MEMORANDUM TO: Len Sanderson, PE
FROM: Len Hill, PE *Len Hill*
DATE: March 10, 1998
SUBJECT: Proposed Glover Road From Ellis Road to US 70, including an Interchange with NC 147 in Durham County

SUBJECT: Potential Glover Road/NC 147 Interchange
Estimates - Durham County

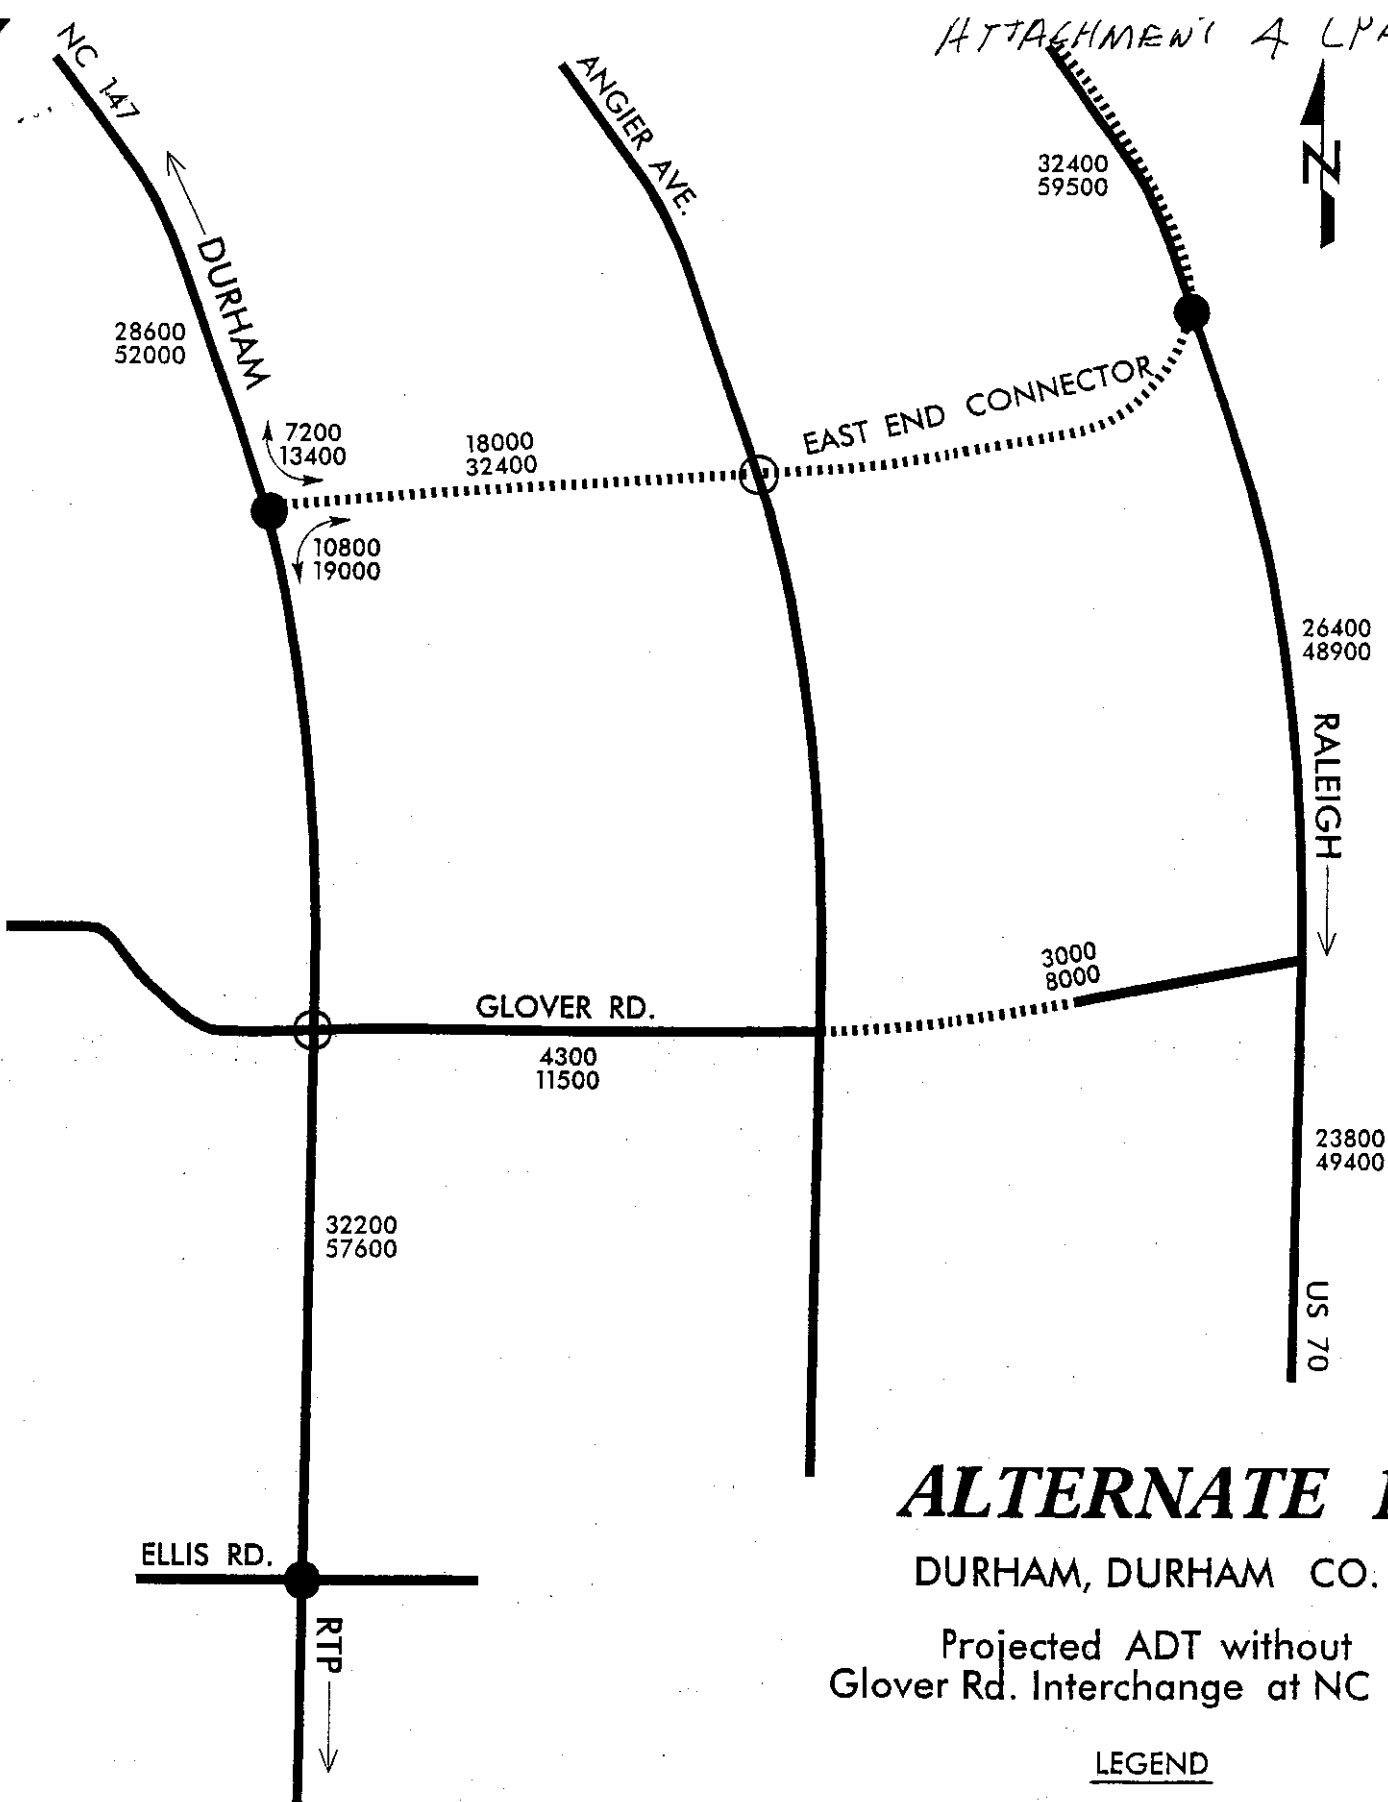
- The distance between Glover Road and the US 70 Connector, located to the North, is approximately 3500 feet. If an interchange is provided, it should be constructed as a half-clover interchange and be located on the south side of Glover Road. This would provide the maximum possible weaving distance between the NC 147/US 70 Connector interchange and the Glover Road interchange.

- Capacity and weaving analysis were performed utilizing 2025 traffic projections.
- A weaving distance of approximately 3000 feet, Glover Road to the Connector, can be provided for the NC 147 northbound traffic. This will provide a level of service D weave.

- A weaving distance of approximately 2800 feet, Connector to Glover Road, can be provided for the NC 147 southbound traffic. This will provide a level of service F weave. This weave is difficult to fully analyze, a left-hand entrance crossing over to a right hand exit.

- The intersection of 5-lane Glover Road and the interchange ramps will operate at an overall level of service B.
- The left turn volume of Westbound Glover Road onto the loop for northbound NC 147 is 384 VPH. This volume suggests a dual left turn lane be provided onto the loop. The additional costs for this were not included in the construction cost estimates.

Due to the close spacing and the unacceptable weaving distance between Glover Road and the US 70 Connector interchange, we do not recommend the addition of this interchange. The weave for the left-hand Connector entrance which must merge to the right to exit at Glover Road is the primary safety concern.
